Well Name: SHERMAN EDWARD	Well Location: T29N / R5W / SEC 3 / SWSW / 36.74925 / -107.35109	County or Parish/State: RIO ARRIBA / NM
Well Number: 2	Type of Well: CONVENTIONAL GAS WELL	Allottee or Tribe Name:
Lease Number: NMNM23048	Unit or CA Name:	Unit or CA Number:
US Well Number: 300392124600C1	Operator: DUGAN PRODUCTION CORPORATION

Subsequent Report

Type of Submission: Subsequent Report	Type of Action: Plug and Abandonment
Date Sundry Submitted: 12/09/2024	Time Sundry Submitted: 04:52
Date Operation Actually Began: 10/28/2024

Sherman Edward #2

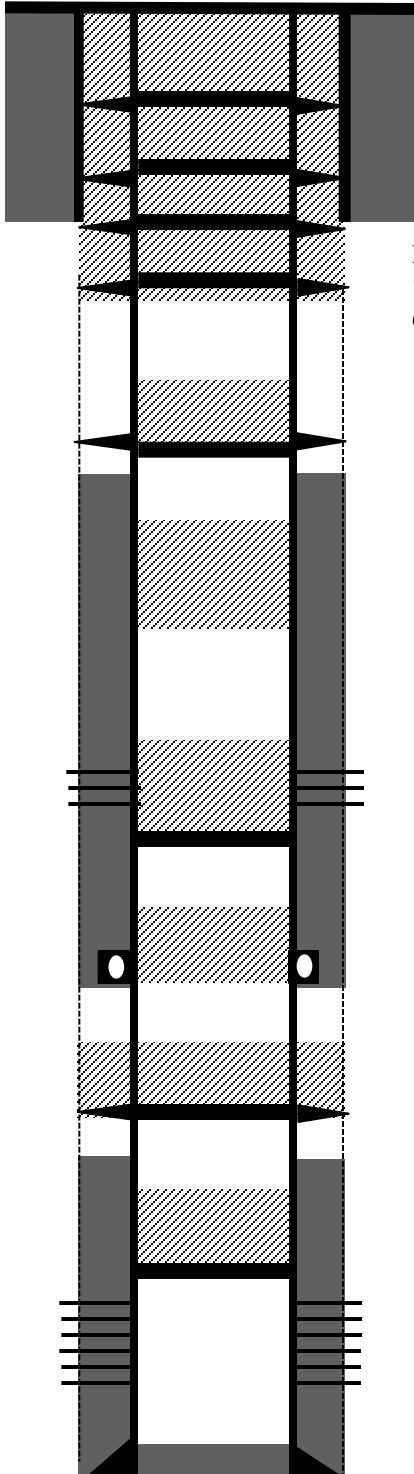
**Plug VII, Inside/outside 5 ½" casing, Perforations at 343', 293', 215', 138', Cement retainers at 328', 275', 200', 281 sks, 323 Cu.ft, Surface casing shoe, 0-343'.**

**Plug VI, Inside 5 ½" casing, Perforations at 880', Cement retainer at 833', 18 sks, 20.7 Cu.ft, Nacimiento, 700'-833'**

**Plug V, Inside 5 ½" casing, 46 sks, 52.9 Cu.ft, Ojo Alamo-Kirtland, 2709'-3058**

**Plug IV, Inside 5 ½" casing, cement retainer at 3467', 48 sks, 55.2 Cu.ft, Fruitland-Pictured Cliffs, 3110'-3467'**

**Plug III, Inside 5 ½" casing, 24 sks, 27.6 Cu.ft, DV tool, 3765'-3915'**

**Plug II, Inside/Outside 5 ½" casing, Perforations at 4485', Cement retainer 4443', 54 sks, 62.1 Cu.ft, Chacra, 4310'-4485'**

**CIBP @ 5535'. Plug I, Inside 5 ½" casing, 24 sks, 27.6 Cu.ft, Mesaverde top & perforations, 5367'-5535'**
